STATE OF TENNESSEE
DEPARTMENT OF TRANSPORTATION
DESIGN DIVISION
NASHVILLE, TENNESSEE 37243-0348

INSTRUCTIONAL BULLETIN NO. 10-15

Regarding New and Revised Standard Drawings

RP-J-9

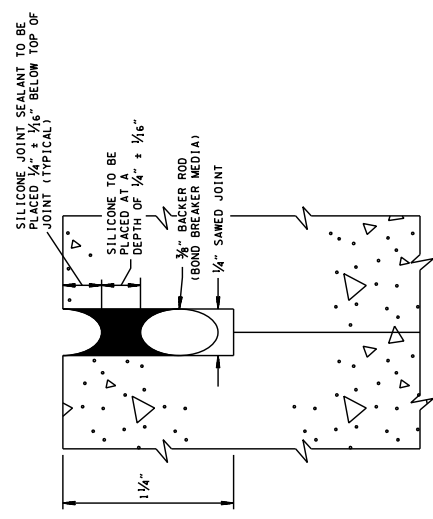
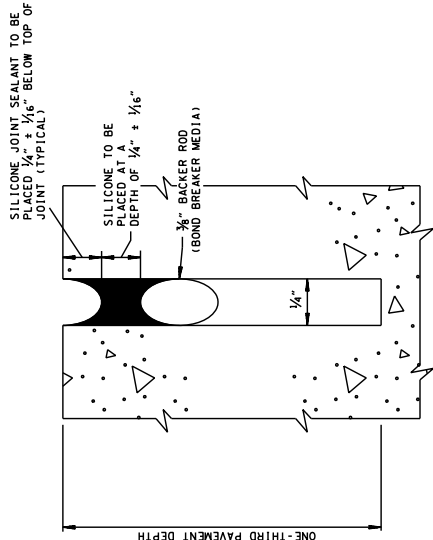
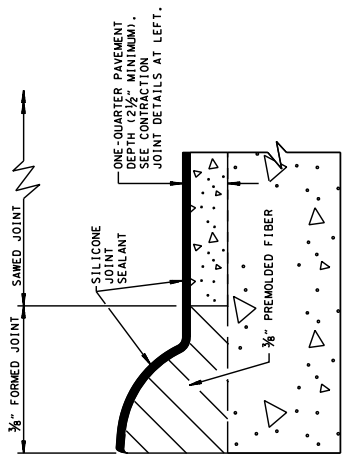
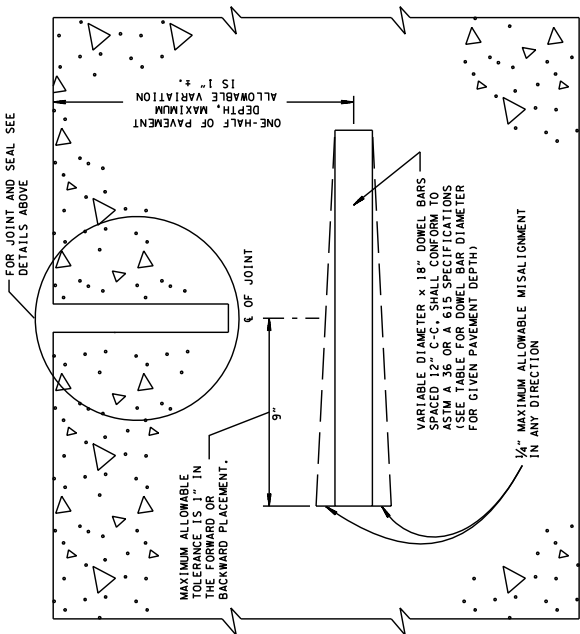
Effective for the May 6, 2011 letting (March 2, 2011 turn-in date), the Roadway Standard Drawing, **RP-J-9** is revised to add 8" pavement thickness.

REV. 9-24-10: ADDED 8" PAVEMENT THICKNESS.

ITEM NO. 711-05.77

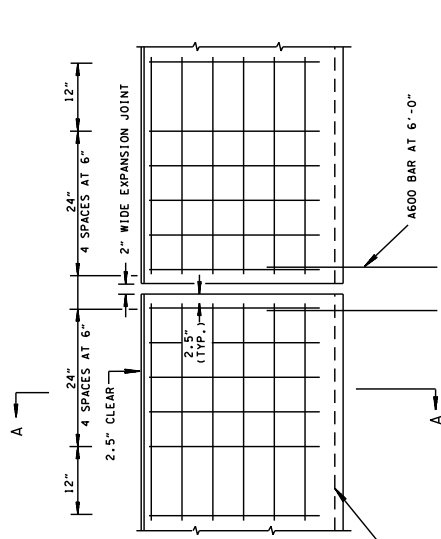
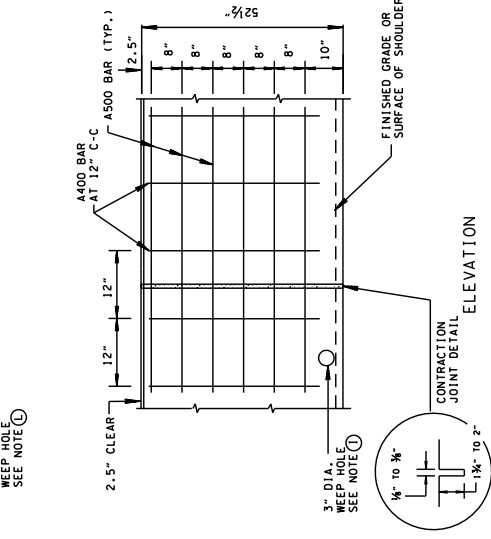
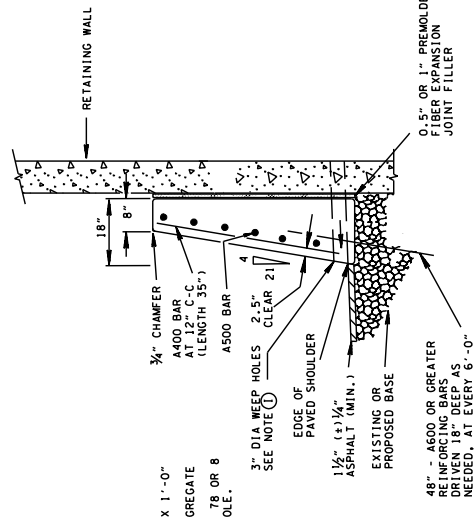
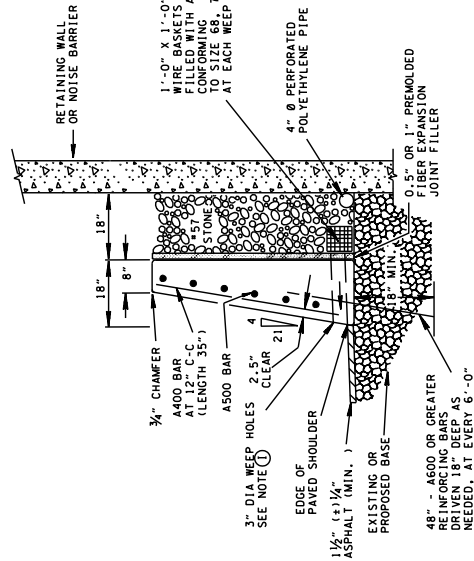
REV. 7-30-10; REVISED REINFORCING STEEL DETAILS AND GENERAL NOTES.
